CP-201000251  
Log # TXNB-10013

**SUBJECT:** COMANCHE PEAK NUCLEAR POWER PLANT, UNITS 3 AND 4  
DOCKET NUMBERS 52-034 AND 52-035  
RESPONSE TO REQUEST FOR ADDITIONAL INFORMATION REGARDING THE  
ENVIRONMENTAL REVIEW AND SUPPLEMENTAL INFORMATION FOR  
PREVIOUS ENVIRONMENTAL QUESTIONS

### **Response to Request for Additional Information Regarding the Environmental Review**

Figure 1  
 Pipeline Stream Crossings  
 CPNPP Site to Lake Granbury

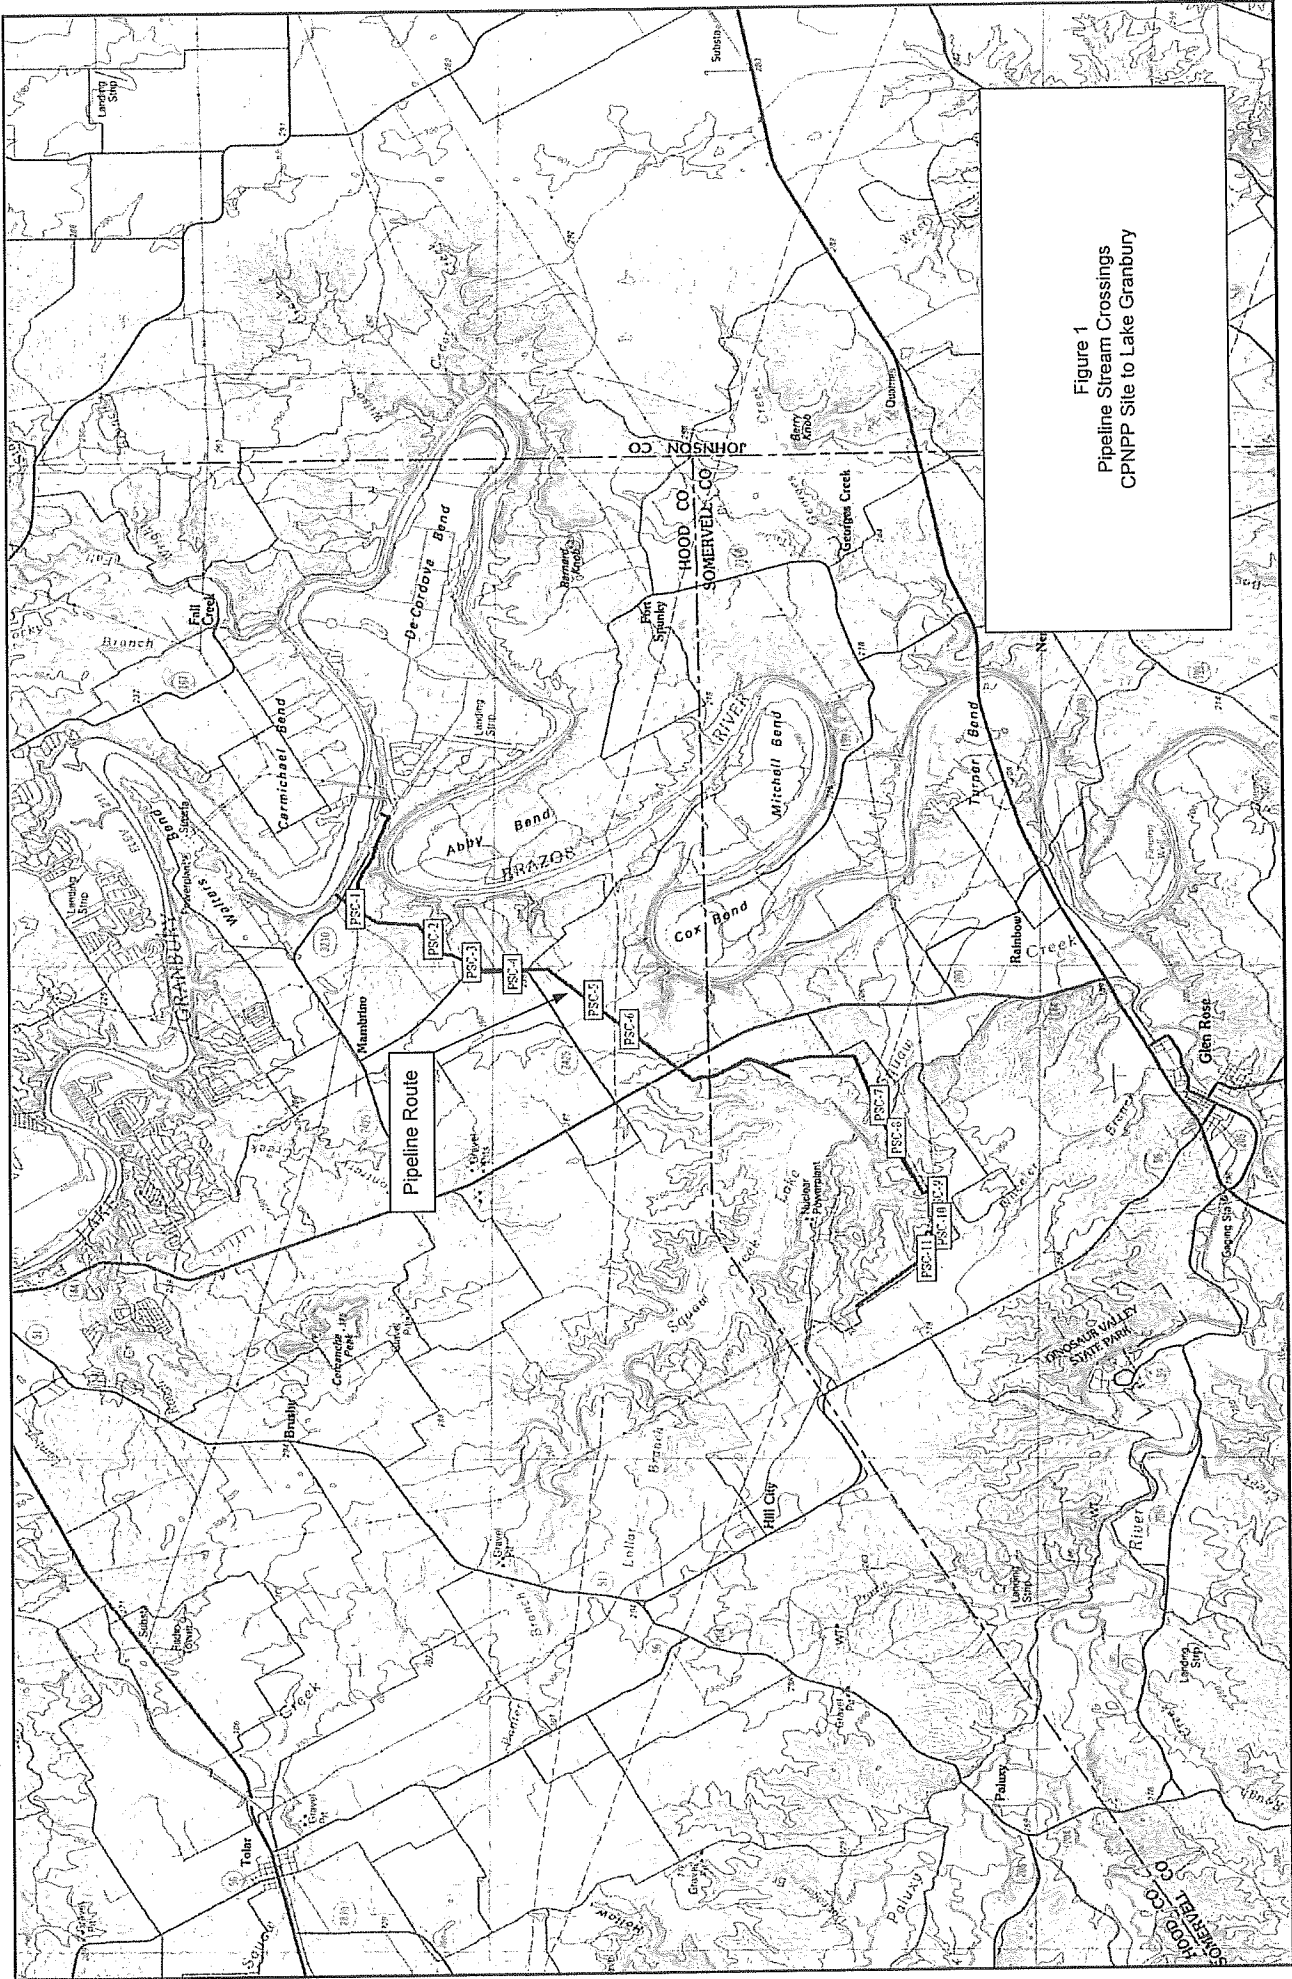
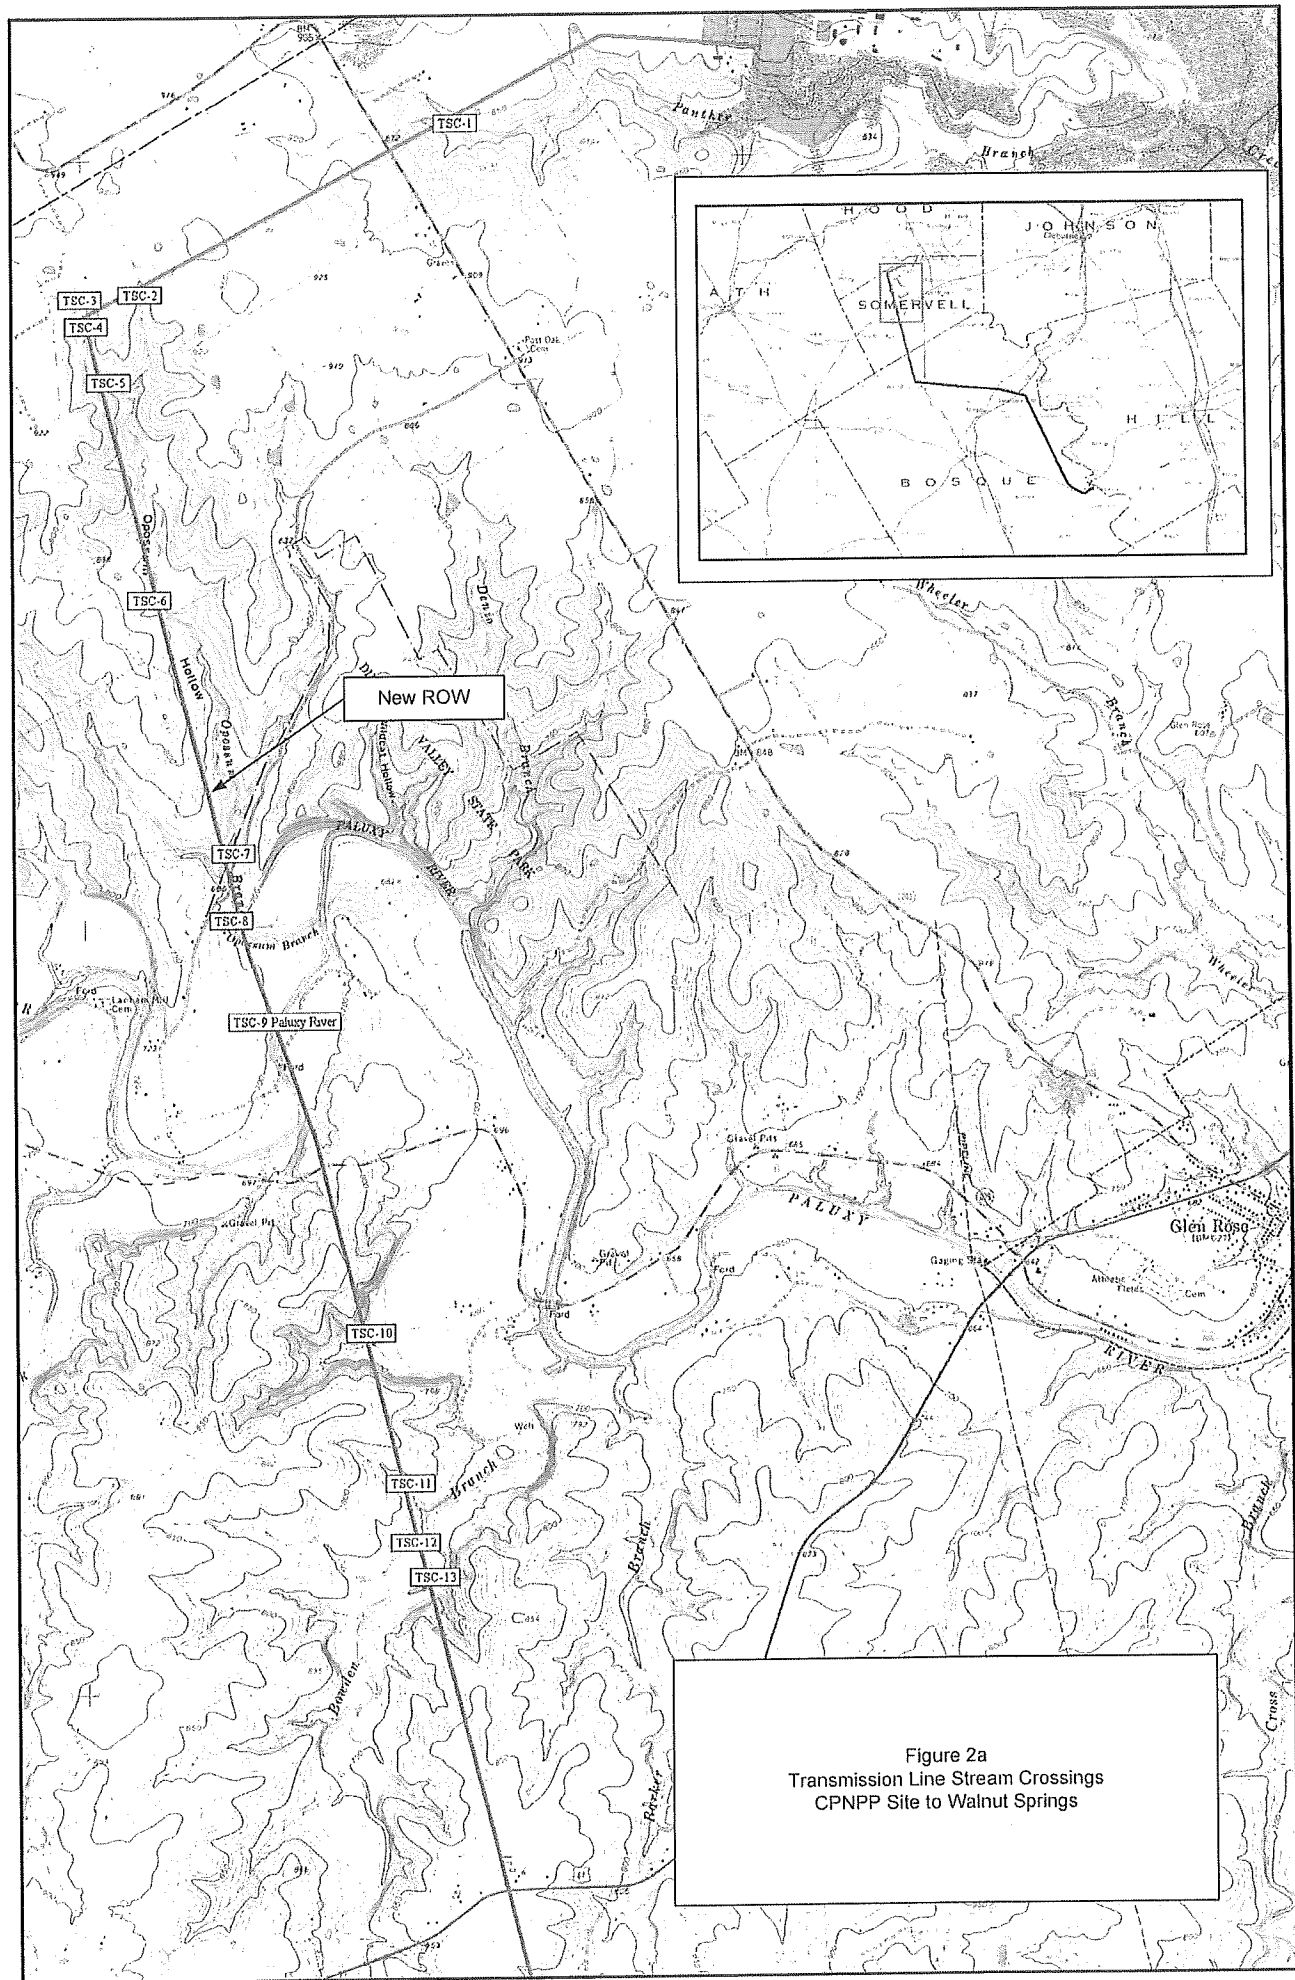
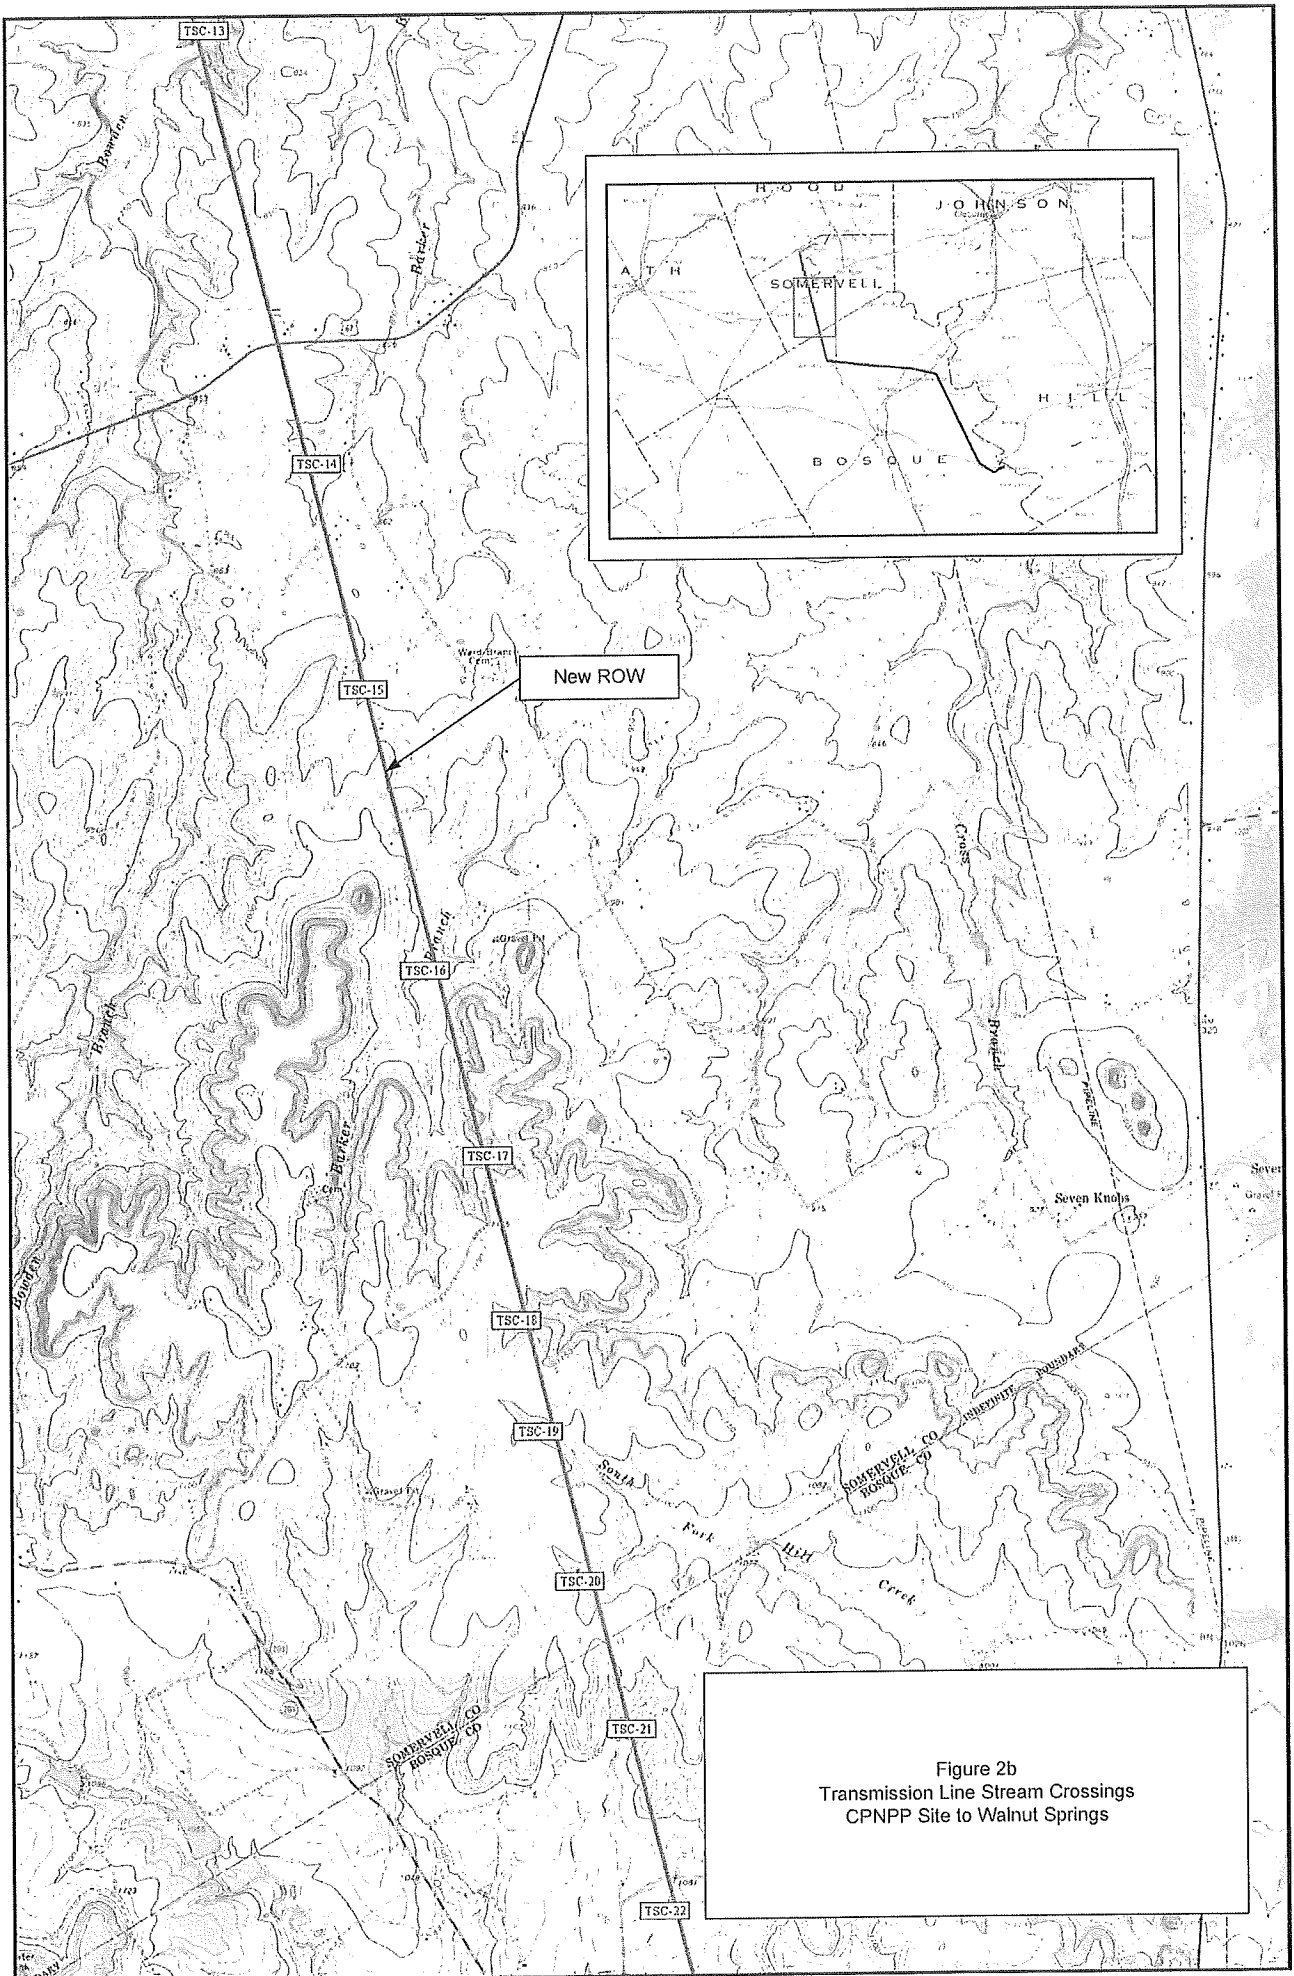
Provide descriptions of any streams that would be crossed by the proposed pipelines between Lake Granbury and CPNPP Units 3 and 4, including their ecological and hydrological characteristics. Provide an estimate of the number of linear feet of streams that would be affected by the construction of Units 3 and 4 pipelines, as well as transmission lines. These data should be provided for each right-of-way (ROW).

Additional cooling water intake and discharge pipelines are expected to be constructed for CPNPP Units 3 and 4 extending from the plant to Lake Granbury (ER Figure 1.1-4). The pipelines are expected to occupy an existing 50-ft ROW and are expected to run parallel to the existing water pipelines. Intake and discharge structures for CPNPP Units 3 and 4 are expected to be placed to the north of and adjacent to the existing Units 1 and 2 intake and discharge structures on Lake Granbury. As discussed in Subsection 2.4.1.2.2, no wetlands or habitat for threatened or endangered species are located on the pipeline ROW. Vegetation consists mainly of grassland and Ashe juniper. Land-use impacts to the ROW during construction are discussed in Subsection 4.1.2. Luminant intends to tunnel at all pipeline stream crossings to minimize or eliminate potential disturbance to streambeds and riparian areas during pipeline construction. Additionally, existing vehicular infrastructure in place at stream crossings from the construction of the existing pipeline is expected to be utilized for CPNPP Units 3 and 4 pipeline construction and maintenance. Streams encountered along the pipeline route and estimated ROW acreages at stream crossings are summarized in Table 1 and stream locations are shown on Figure 1.

Three single-circuit transmission lines are located on existing ROWs and use existing tower structures (ER Figure 1.1-5). Two double-circuit expansions require the construction of new towers on new or expanded transmission line ROW that is 160 ft wide. The first is a 45-mi line to Whitney and the second is a 17-mi line to DeCordova. No land-use impacts are anticipated from the transmission line construction activity located on existing or expanded ROWs as vegetation maintenance is already performed. Therefore, only new ROW that does not parallel an existing transmission ROW was analyzed for new impacts. Land use along the DeCordova ROW consists mainly of grassland, while the land use along the Whitney ROW consists of primarily grassland with some deciduous and evergreen forest. Updated Table 2.2-4, provided with the response to Question GEN-08, shows the land-use acreages in transmission line ROW.
